**Federal Aviation  
Administration**

# FAA Initiative to Address Noise Concerns of Santa Cruz/Santa Clara/San Mateo/San Francisco Counties

## **UPDATE ON PHASE TWO**

**November 2017**

**Figure A1: Comparison of Golden Gate arrivals (May 2014) and BDEGA arrivals (May 2016)**

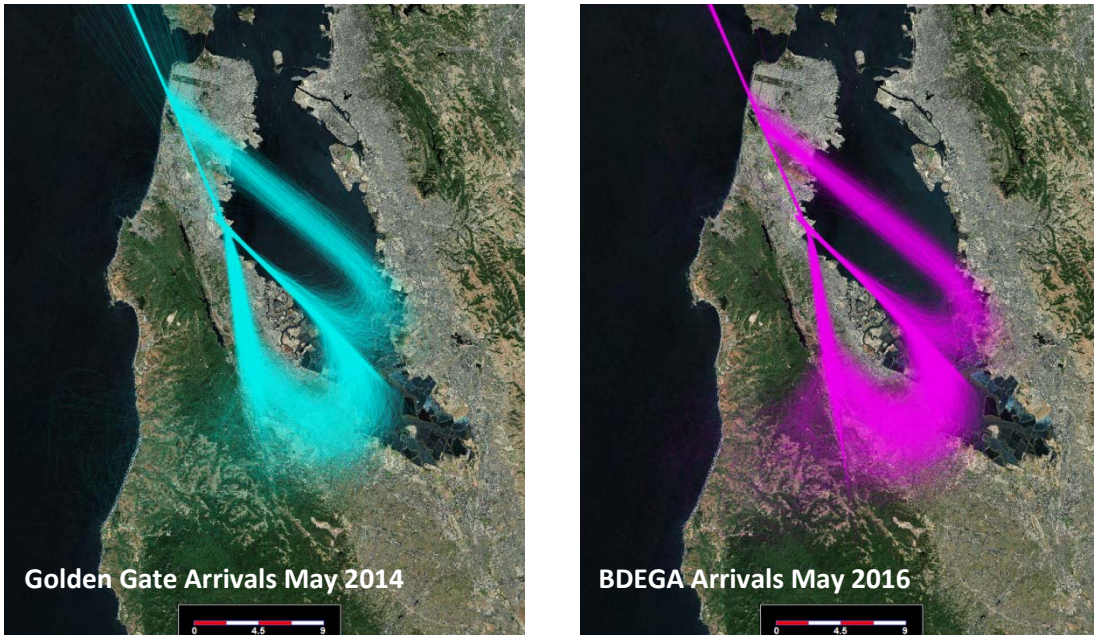
**2.4 The FAA provide data on Golden Gate/BDEGA lateral track locations pre-NextGen and post-NextGen and if new procedures can use headings, not tracks, in procedure design.**

The FAA reviewed the identified arrivals: the Golden Gate and BDEGA arrivals. The Golden Gate arrival states, “...via SFO R-303 to SFO VOR/DME. Expect RADAR vectors to final approach course.” Aircraft that flew this arrival navigated to the SFO VOR/DME via the SFO 303° radial, which is a conventional, or non-precision, method of navigation. Upon reaching the SFO VOR/DME, aircraft on the Golden Gate arrival were typically instructed to fly a 140° heading. Note, the Golden Gate arrival does not stipulate a 140° heading.

Therefore, aircraft that historically flew the Golden Gate arrival and that currently fly the BDEGA arrival essentially perform the same maneuver after crossing SFO/DME / BRIXX. Figure A1 (above), a review of one month of Golden Gate arrival aircraft (Teal) and one month of BDEGA arrival aircraft (Pink), supports this conclusion.

**Figure A2: SEPDY Reporting Point relative to SSTIK waypoint.**

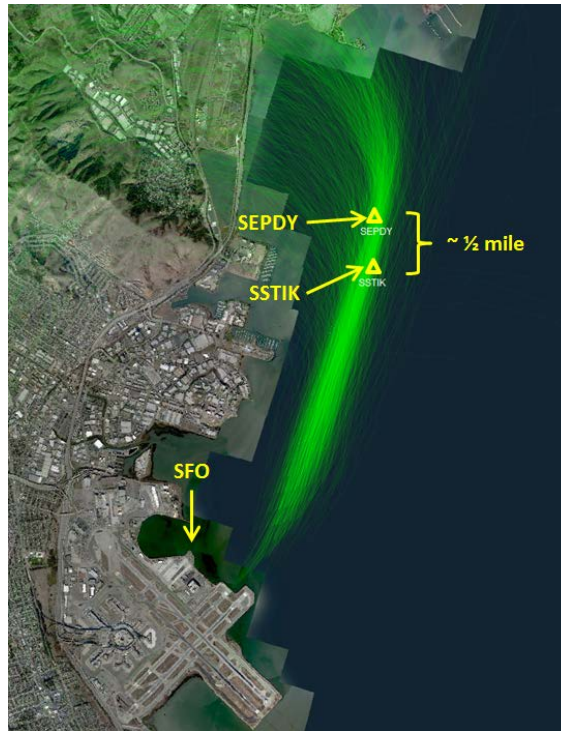
**2.37 SSTIK: Avoid non-safety vectoring prior to SEPDY waypoint.**

SEPDY is a reporting point from the conventional PORTE and OFFSHORE departure procedures. The SSTIK RNAV departure, which serves as PORTE and OFFSHORE's replacement for nearly all southbound aircraft, does not include the SEPDY reporting point. While not a part of the SSTIK departure procedure, the point in space that is SEPDY already sees the majority of SSTIK departures passing through it, as illustrated above in Figure A2.

**Figure A3: BDEGA / DYAMD / Bay Area Airspace**

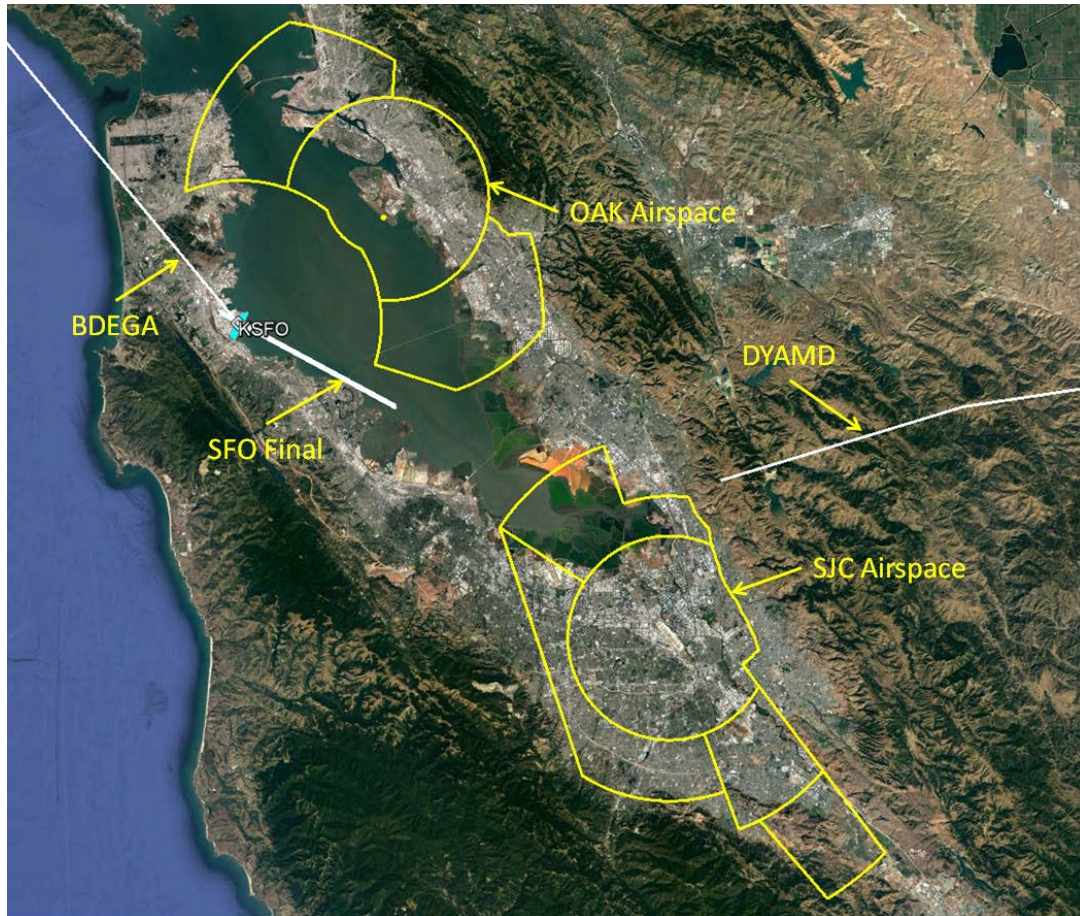
**3.12 Research reasons for the continued increased use of the BDEGA west leg from May 2010 – present.**

SFO operations have increased 4% from 2014 to 2016, with an 18% and 4% increase in the BDEGA and DYAMD arrivals, respectively. It is important to understand that this increase in volume and the times of day that they fly is a result of Air Carrier scheduling. The FAA’s role is to safely manage these aircraft from the time they push back from their departure airport jet way to the time that they reach their arrival airport jet way.

As noted in Figure A3 and in previous meetings with the Select Committee and SFO Roundtable, the ability to route a BDEGA arrival to the East downwind is dependent on the density of aircraft on the DYAMD arrival and the volume of traffic landing at OAK. Straight-in aircraft, as aircraft on the DYAMD arrival are to SFO, largely have priority over aircraft on the downwind. The reason for this is DYAMD aircraft are constrained by surrounding airspace to the North and South (OAK and SJC, respectively), and vectoring aircraft on the straight-in affects every trailing aircraft in the line – increasing the controller’s workload significantly. The same is true, to a smaller degree, of aircraft on the East downwind. This leg also has the constraint of OAK airspace to the North and the SFO Final to the south, leaving very little room to maneuver aircraft for a sequence. Because of these two limiting factors, aircraft on the BDEGA can only be routed

**Figure D1: Intercept FAC below the glideslope**

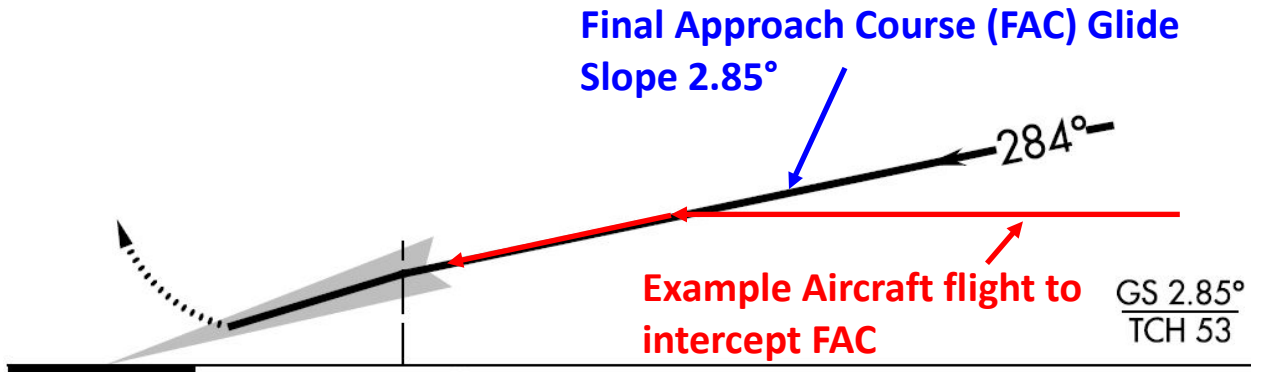
### **1.21 All air traffic in the vicinity of the MENLO waypoint (including vectored traffic from other procedures) be kept at altitudes of 5,000 feet or higher, even if not crossing directly over the MENLO waypoint.**

The average altitude of vectored traffic in the vicinity of MENLO waypoint is approximately 4,600 feet MSL. Aircraft that fly in the vicinity of MENLO with the intention of landing on Runways 28L or 28R at SFO are subject to the same descent requirements of those that cross MENLO on an arrival. Those requirements are detailed in the FAA's NorCal Phase One Report, 1.a.i. and Appendix D. For safety considerations, and to fly a stabilized approach, aircraft must be descended in order to intercept (join) the Final Approach Course (FAC) at or below the glideslope (See Figure D1).

**Figure D5: Graphical Depiction of Routes**

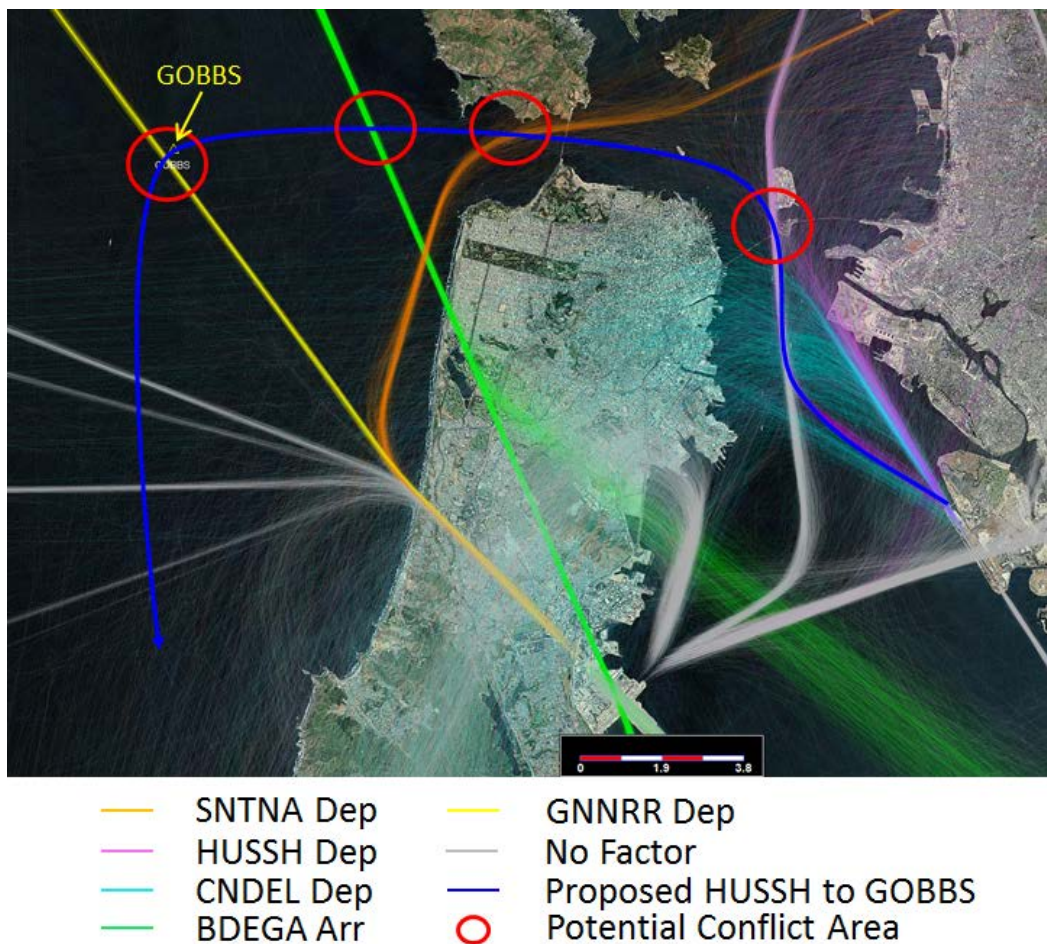
**2.31 Determine if a revised southbound transition (with additional waypoints) for the CNDEL procedure could “contain” the flight paths further west (GOBBS and south) to allow expanded clear space for possible modification of the SSTIK departure.**

In the above image (Figure D5), the teal tracks represent current CNDEL departures, while the pink tracks represent current HUSSH departures. The blue line approximates the FAA’s understanding of the Roundtable’s recommendation – that the CNDEL departures (teal), a day and nighttime departure procedure, be routed on a track approximating the blue line to GOBBS, then South. CNDEL, as it is published today, is designed to be laterally separated from SSTIK
